## Comments from Industry (I)

2 February 1987

I-1 We have reviewed the draft 1002 Report, particularly those sections dealing with terrestrial biology. Our specific comments are attached. In general, the baseline data collected in ANWR for 1002-related biological studies are of high scientific merit, summarized in a brief (understandably), but informative fashion, and should be of great value in the decision-making process and for assessing development-related impacts. In our opinion, most issues regarding potential impacts have been adequately defined, with the exception of the probability for direct loss of habitats and populations. Sections on "The Effects on the Biological Environment", especially in regard to loss of coastal insect relief for caribou and staging habitat for snow geese, need considerably more support from existing data. At a minimum, more detailed explanations of the criteria and rationale used for estimating habitat loss, amounts of displacement, and population declines are necessary. Without these elements, the impact assessments lack credibility.

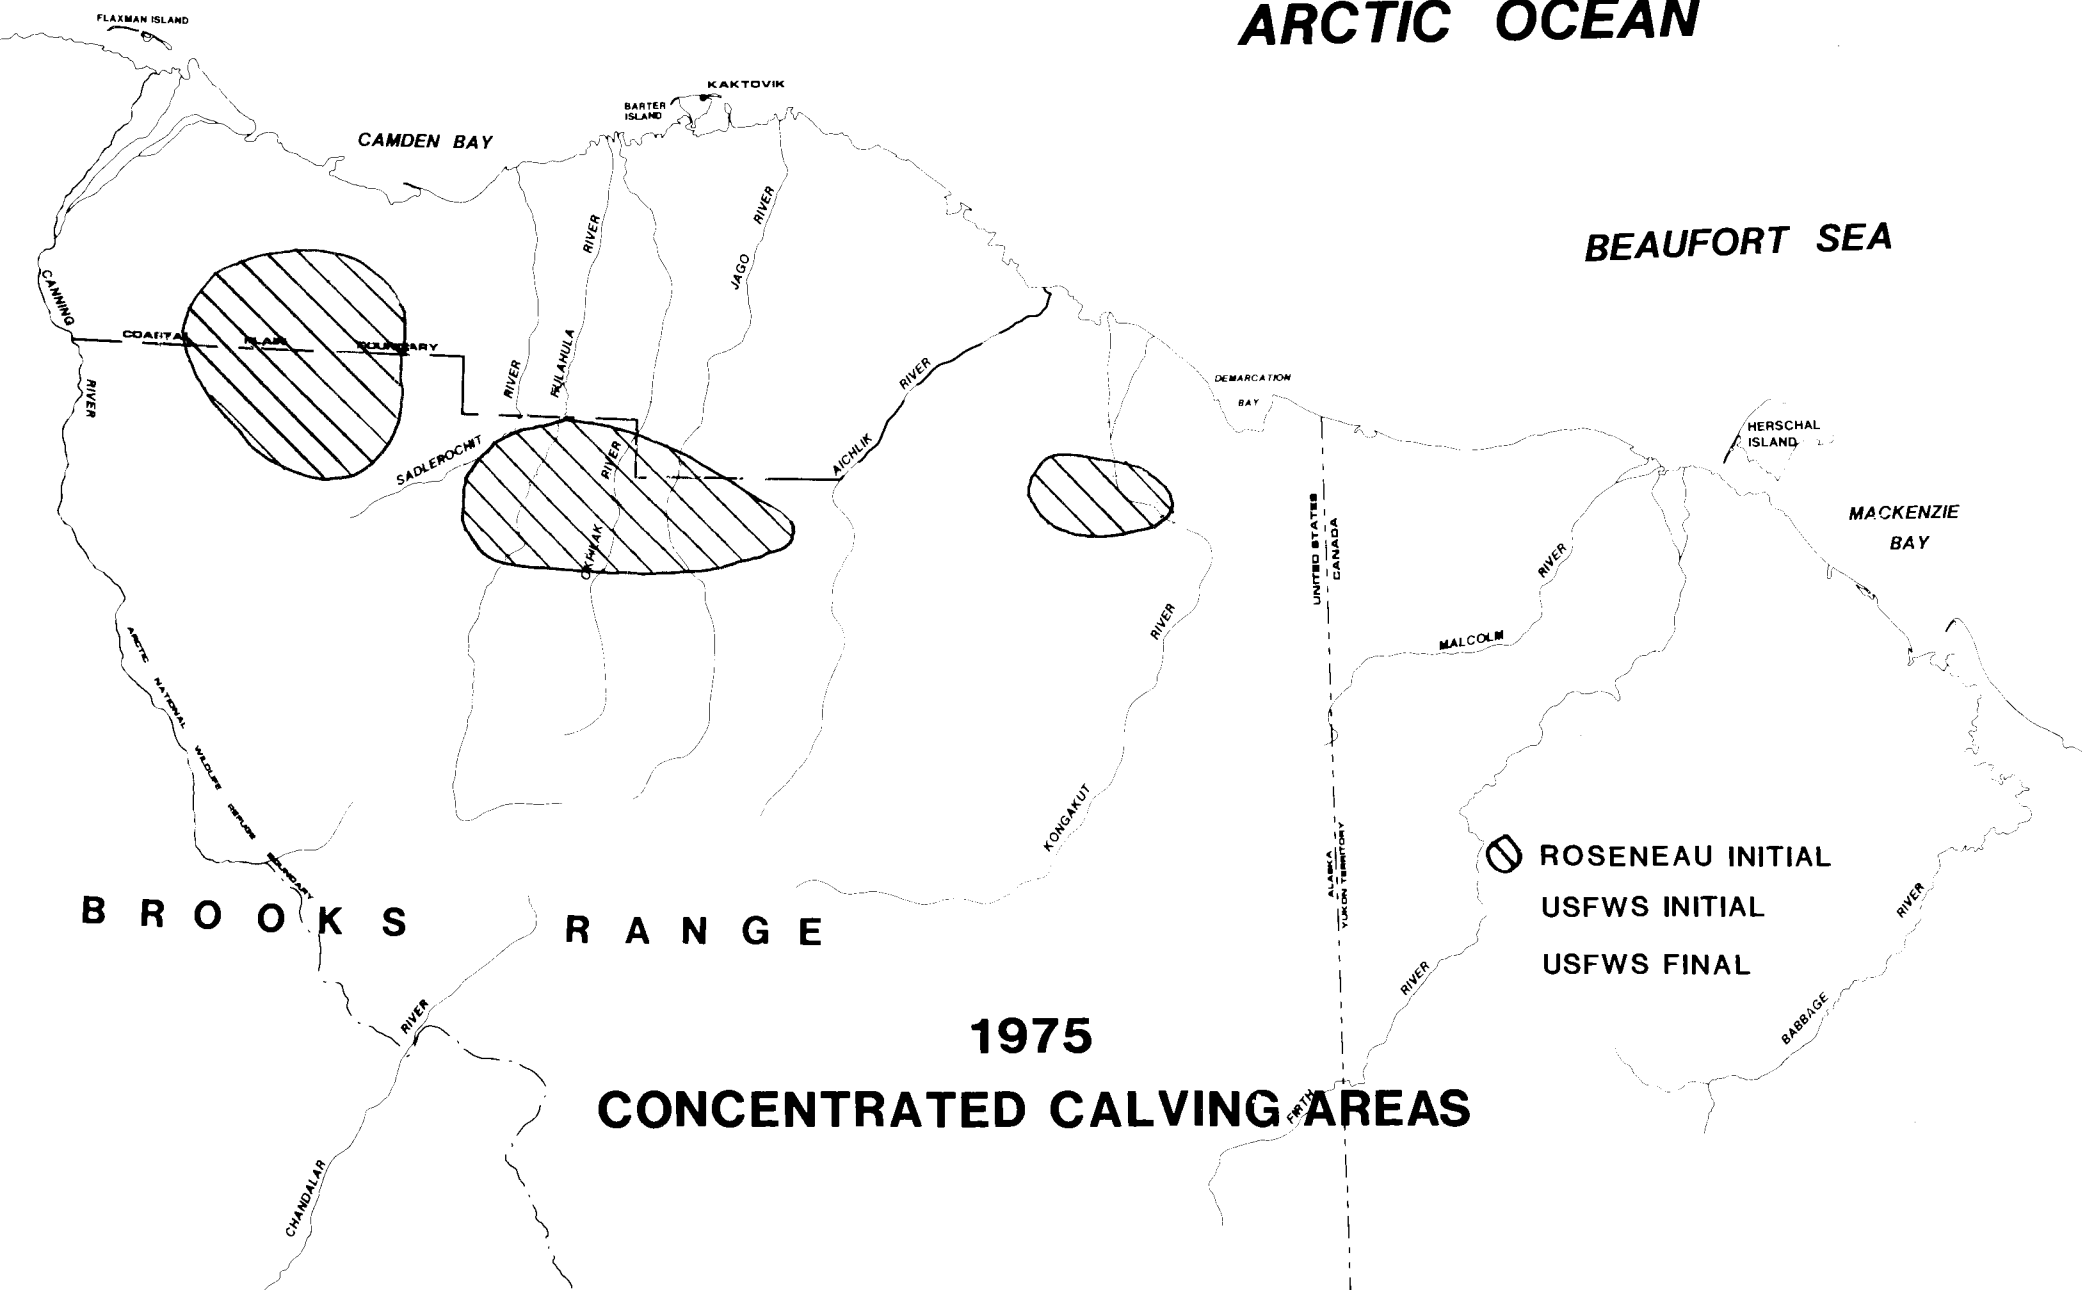
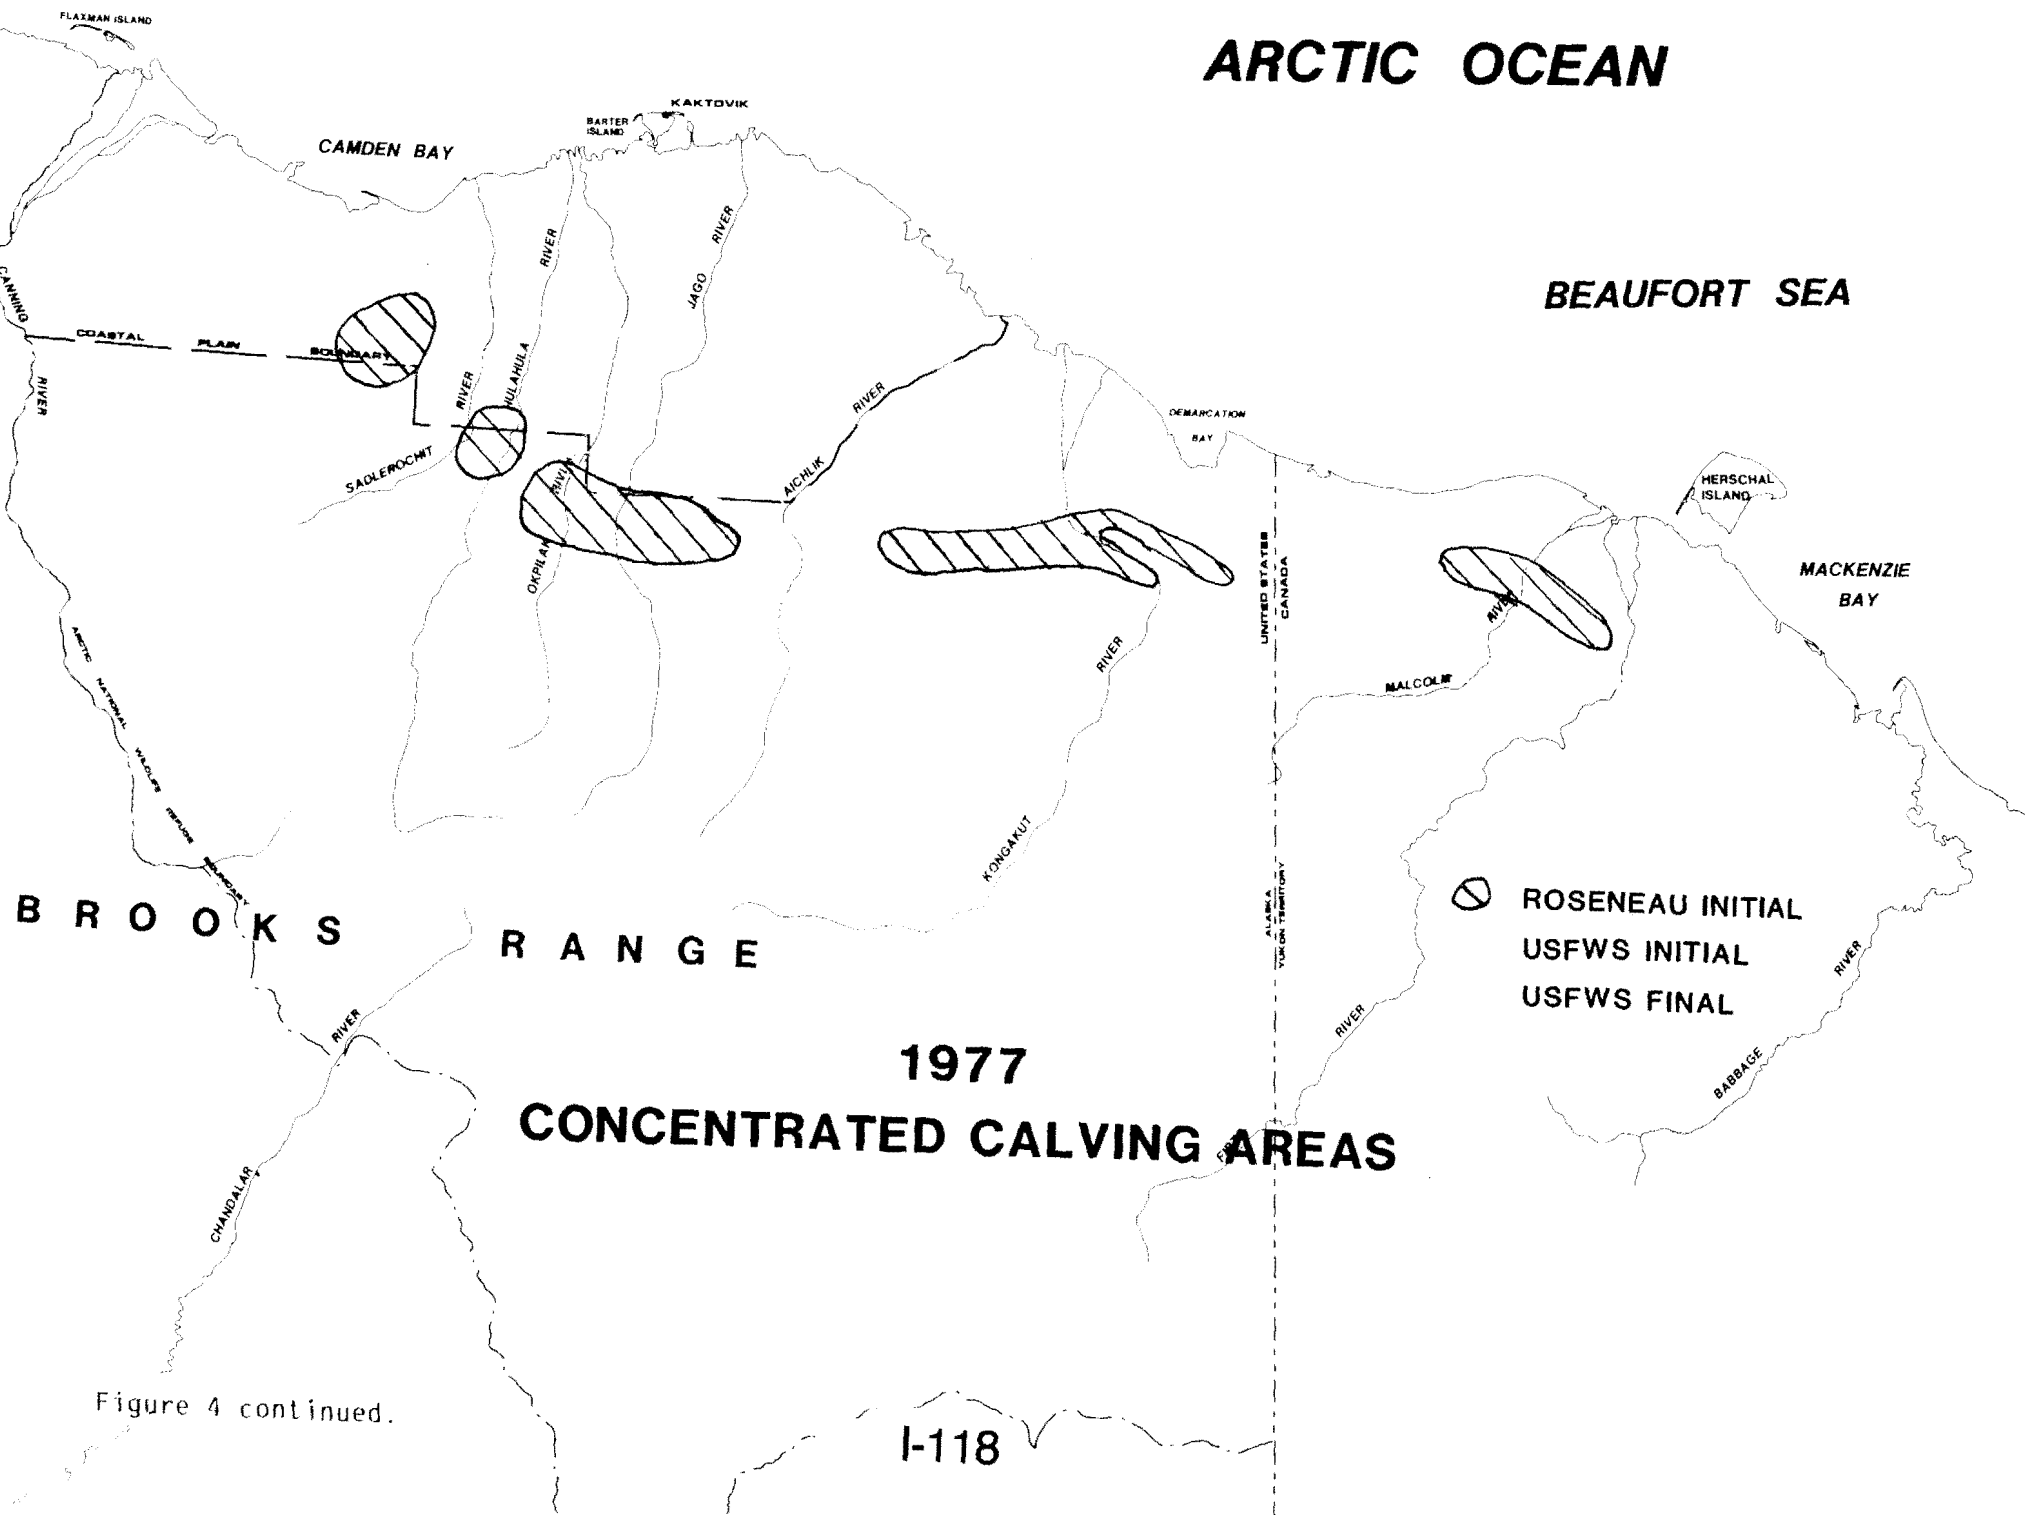
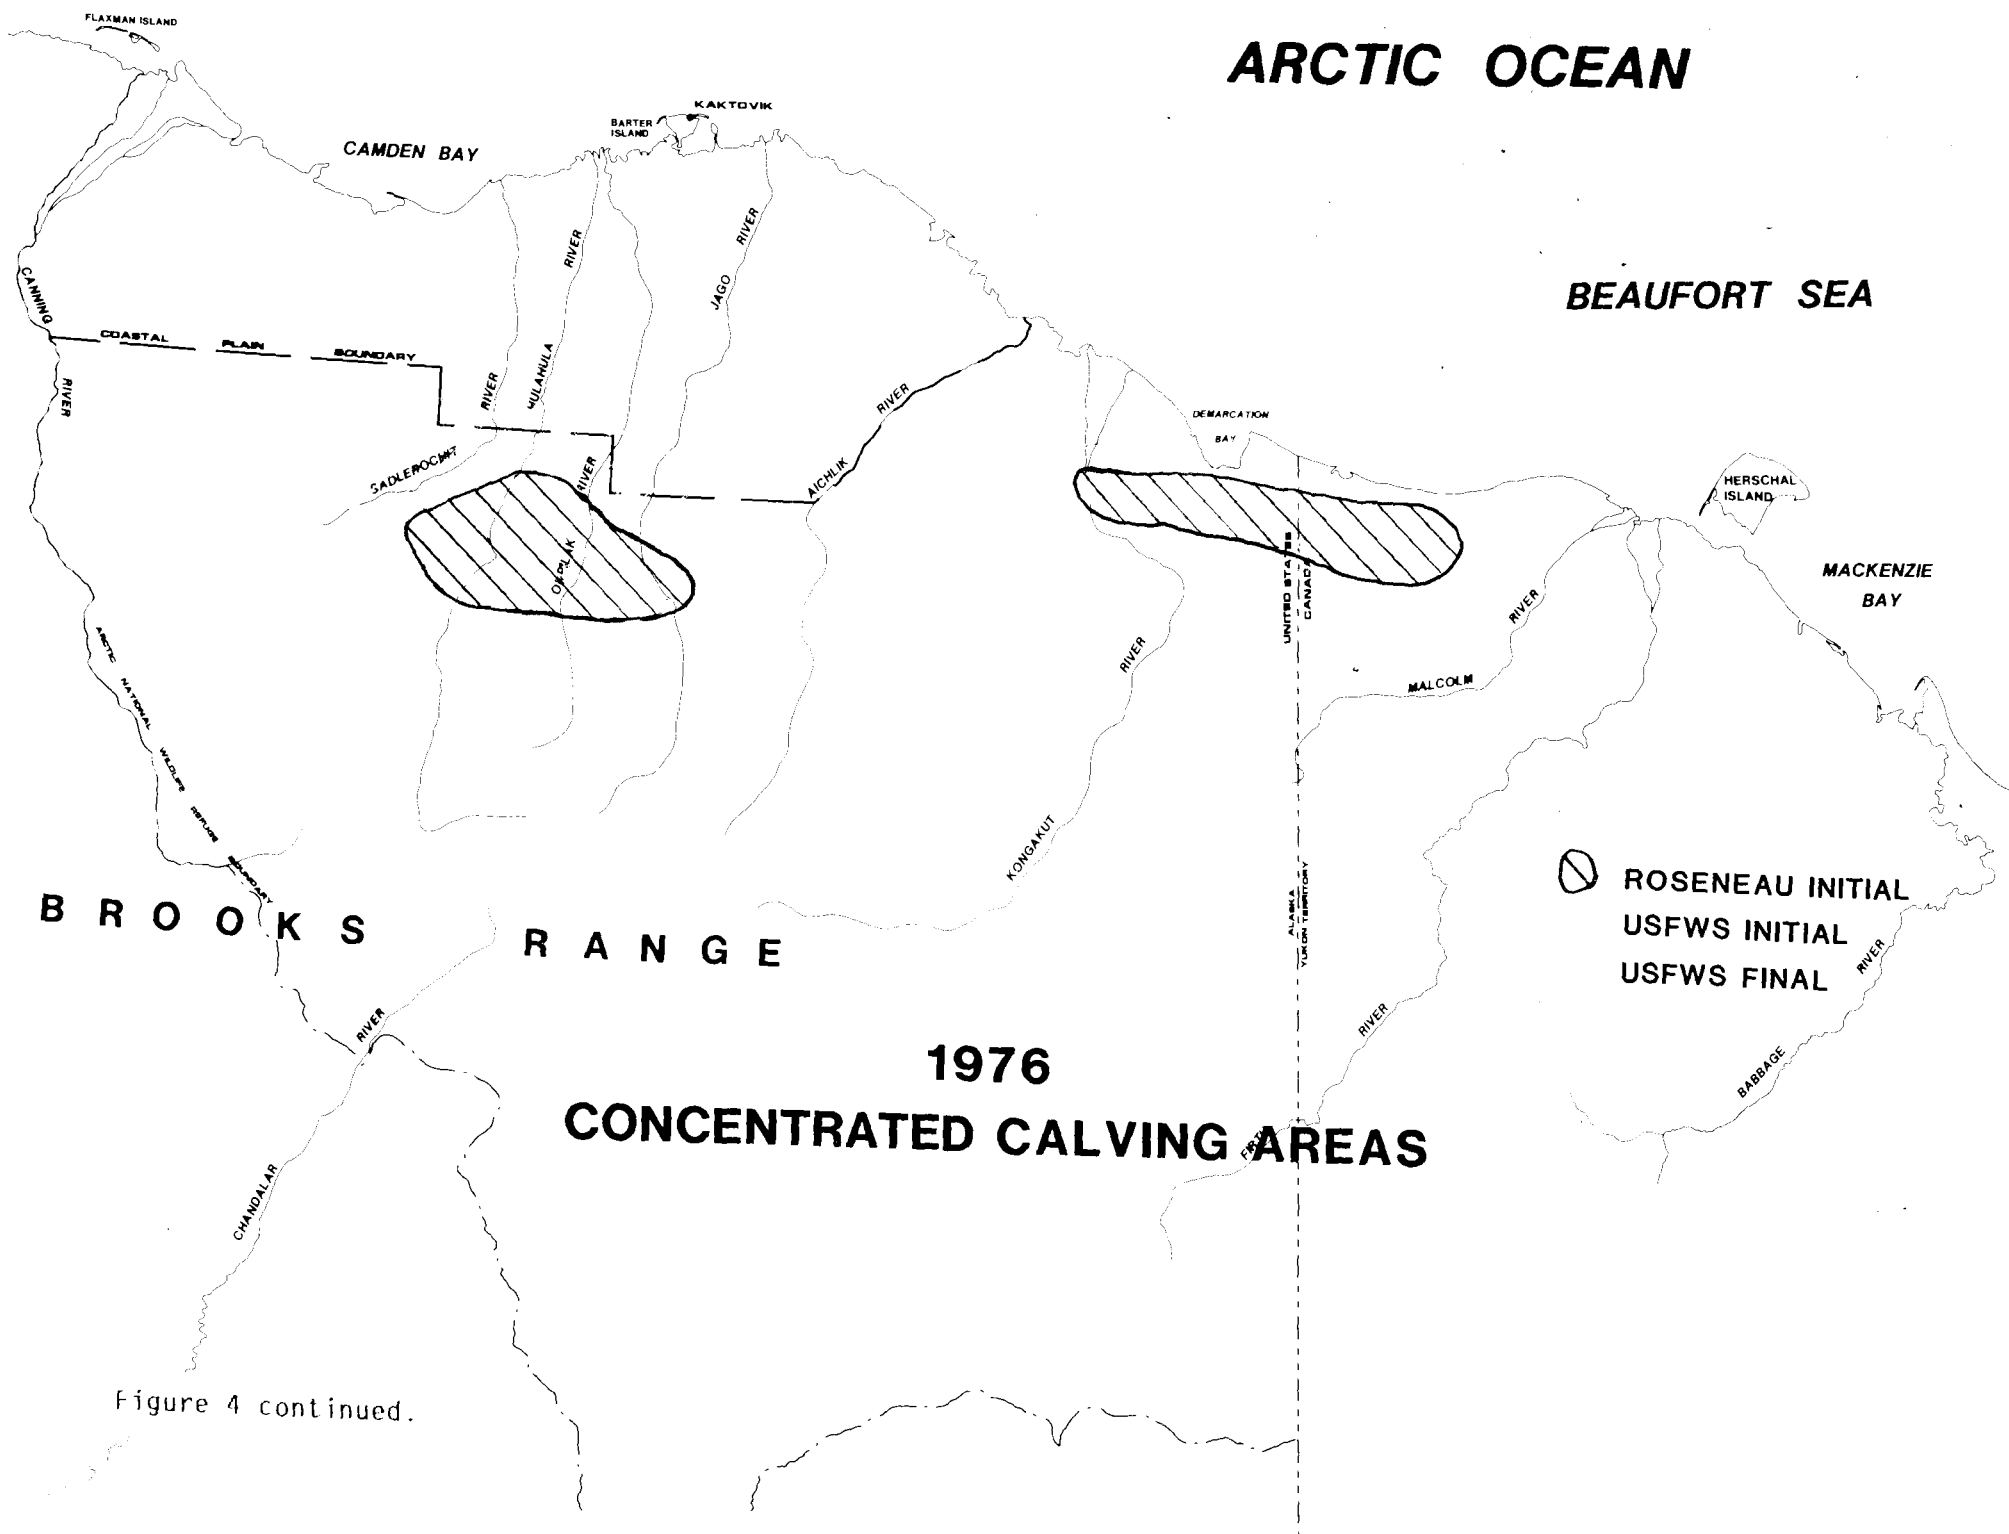
The years 1975, 1976, and 1977 will serve to indicate the magnitude of the alterations that have crept into the draft report's analysis of locations of PCH calving concentration areas. Figure 4 shows three different representations of the same information: 1) an accurate transfer of data from the original maps (Fig. 3); 2) the version presented in the ANWR Initial Baseline Report (FWS 1982) (Fig. 3); and 3) the version from FWS computer files which formed the basis of Plate 2A in the draft report. It is clear that there are substantial differences between these three versions, and that there are significant problems associated with transferring data from very small-scale maps to larger-scale maps. The larger-scale maps (Plate 2A) cannot responsibly be used for any purpose other than to provide a general indication of areas that have received higher than average use by calving caribou in some years. It is inappropriate to state that these areas accurately represent locations where caribou were present in densities equal to or greater than 50 animals/square mile, or to designate a specific tract formed by composites of such areas as a special resource category with assumed site characteristics that are "unique and irreplaceable on a national basis".

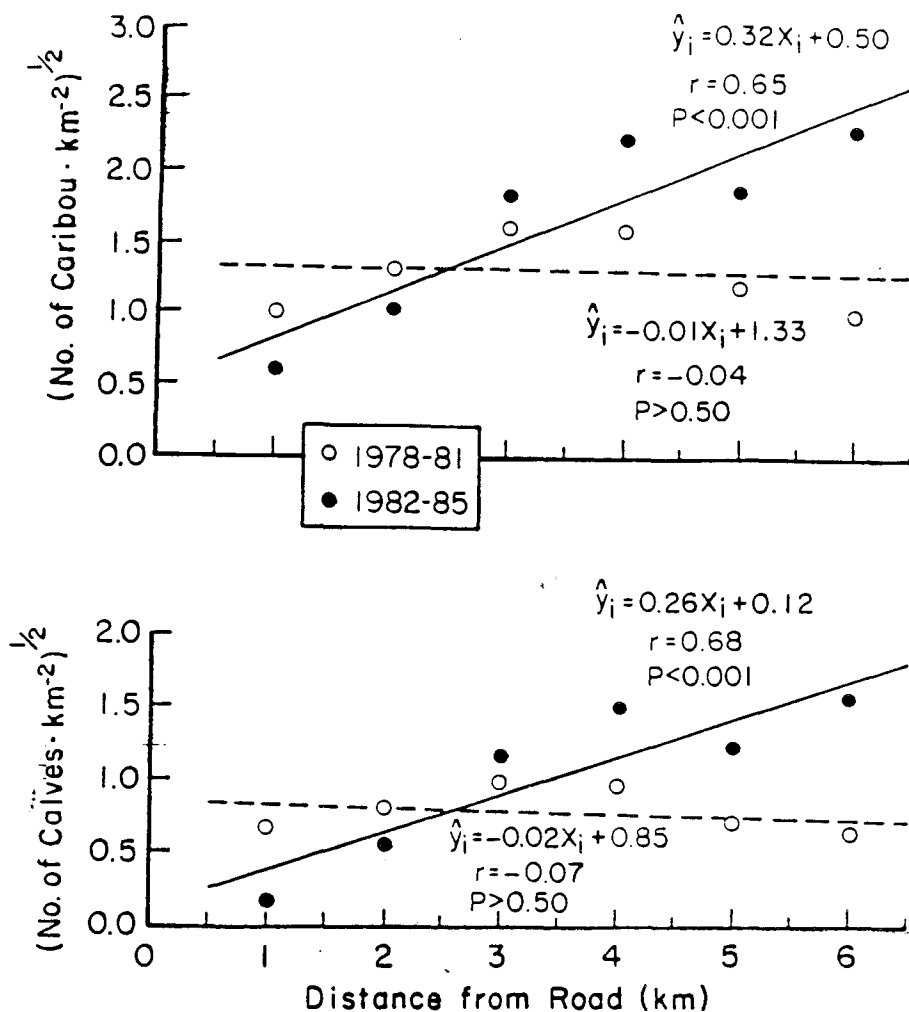
Figure 5 presents graphs from the Dau and Cameron paper showing the relationship between the square root of the density of all caribou and also of calves only, and distance from the road. The data points shown are the means of four years; no information about year-to-year variability is given. The data were collected by helicopter surveys conducted during the four years prior to road construction (1978-1981) and the four years following road construction (1982-1985). The intent, of course, was that the first four years' data would serve as a control against which to compare caribou distribution after the road was in place and development had begun.

Use of the square root transformation and of calculated regression lines (Fig. 5) gives the impression that caribou density was evenly distributed within 6 km of the alignment prior to construction of the road, but afterwards was low near the road and high away from it. If we take the graphs in Fig. 5 at face value, an effect relating to the presence of the road appears to continue out to at least 6 km. However, removing the square root transformation gives quite a different picture (Fig. 6). Examination of the non-transformed data leads to four observations:
